Suite 301/302
ORIGINAL LAYOUT.

SUITES 301/ 302 - LONG ISLAND

Royal Pine Homes • 25 Boker Hill Blvd - Stouffville, ON • Feb 14, 2018

DRAWING AS PER AGREEMENT OF PURCHASE AND SALE (before decor appointment)

LONG ISLAND
301/302

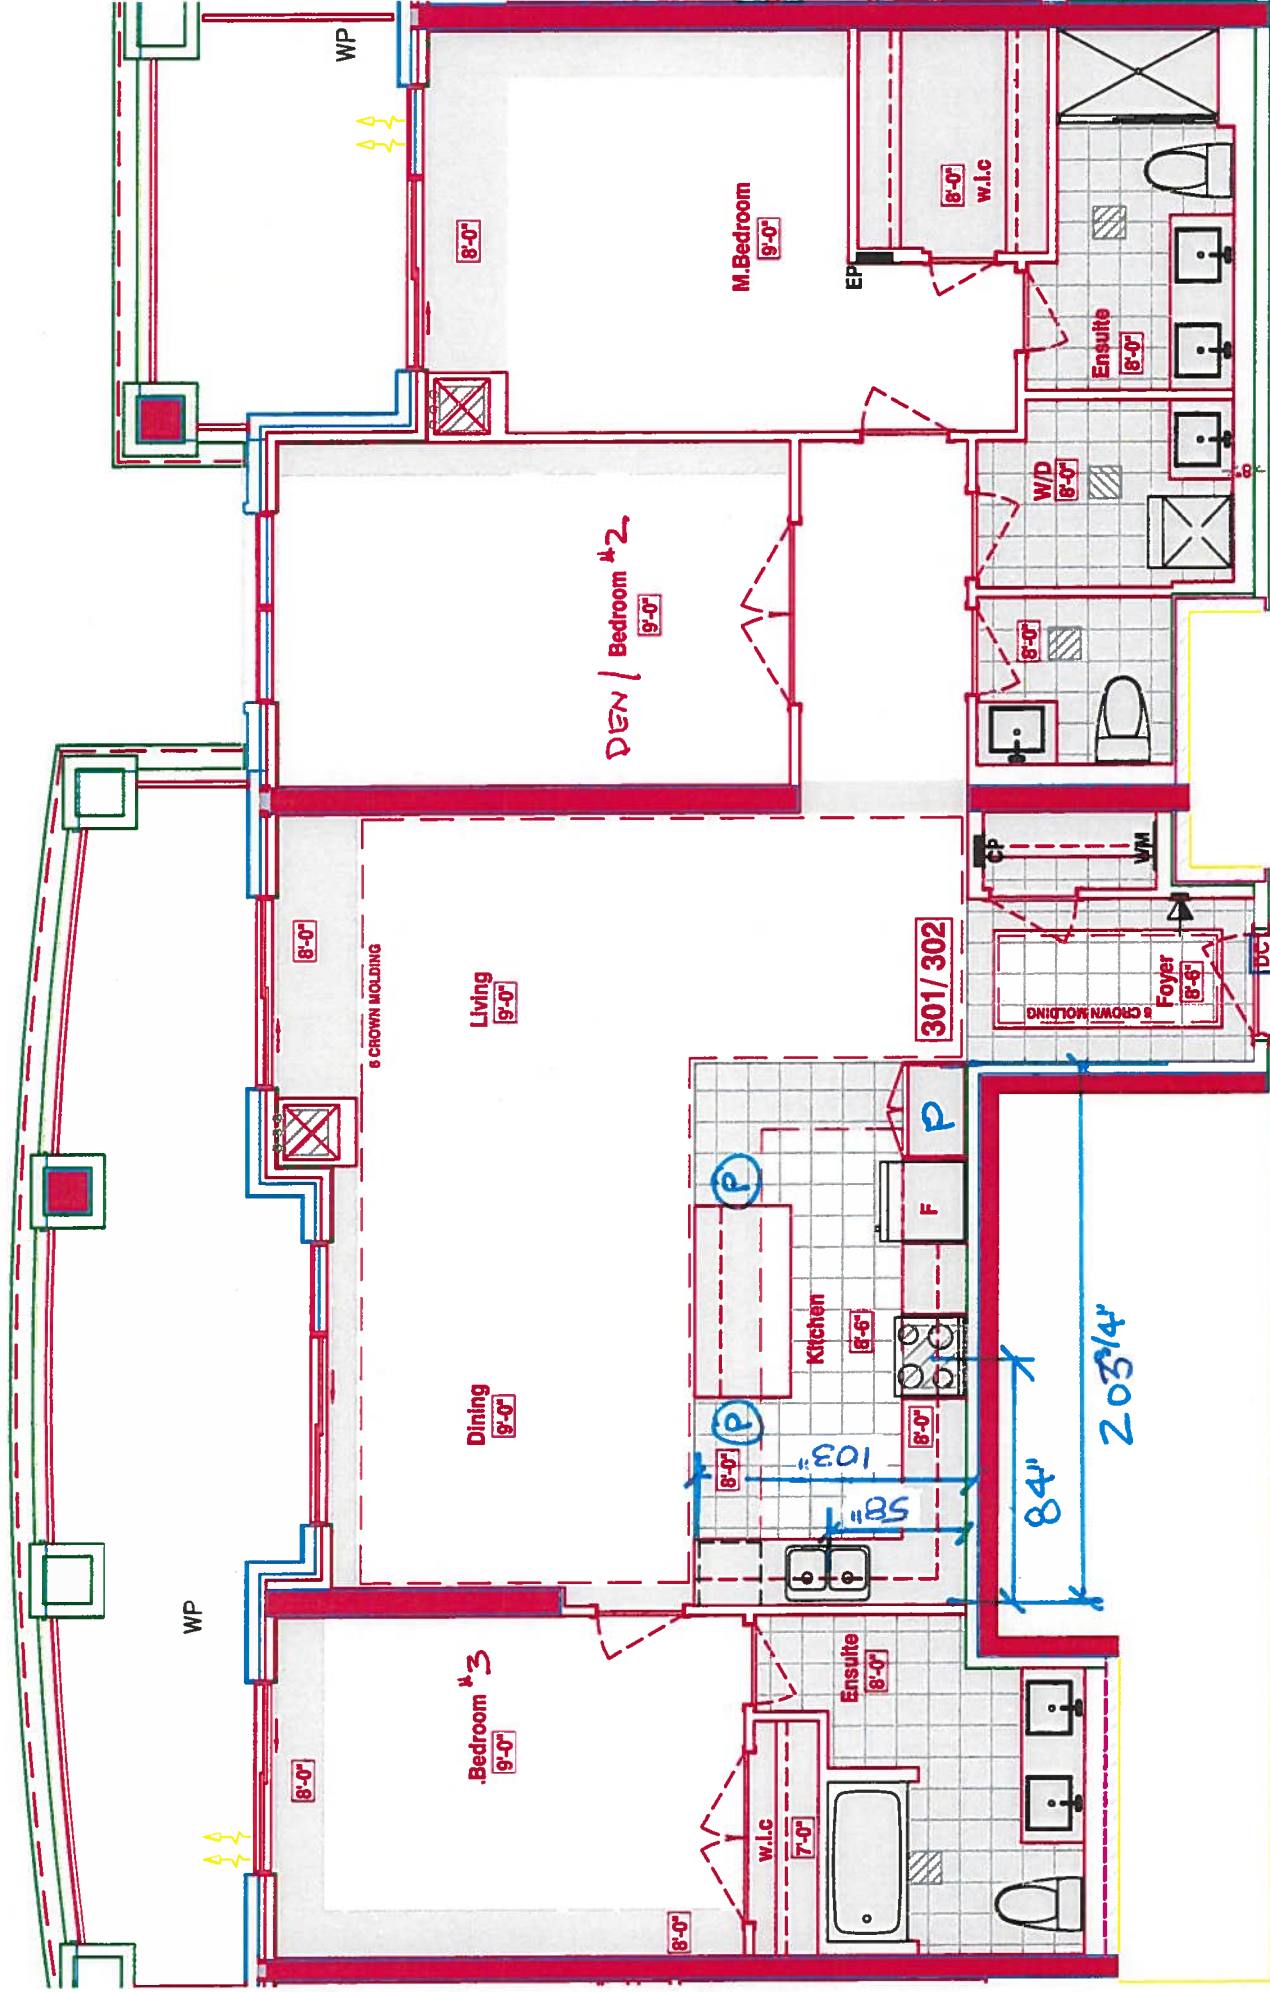
CHANGE SWING.

KITCHEN.

- OPT. OF STD OR 1ST UPGRADE KITCHEN CABINETS
- OPT OF STD OR 1ST UPG APPLIANCE PKG.
- (P) = 2x PLUGS ISLAND
- 5x: PUCK LIGHTS (STD)
- 6x: PUCK LIGHTS 1ST UPG.
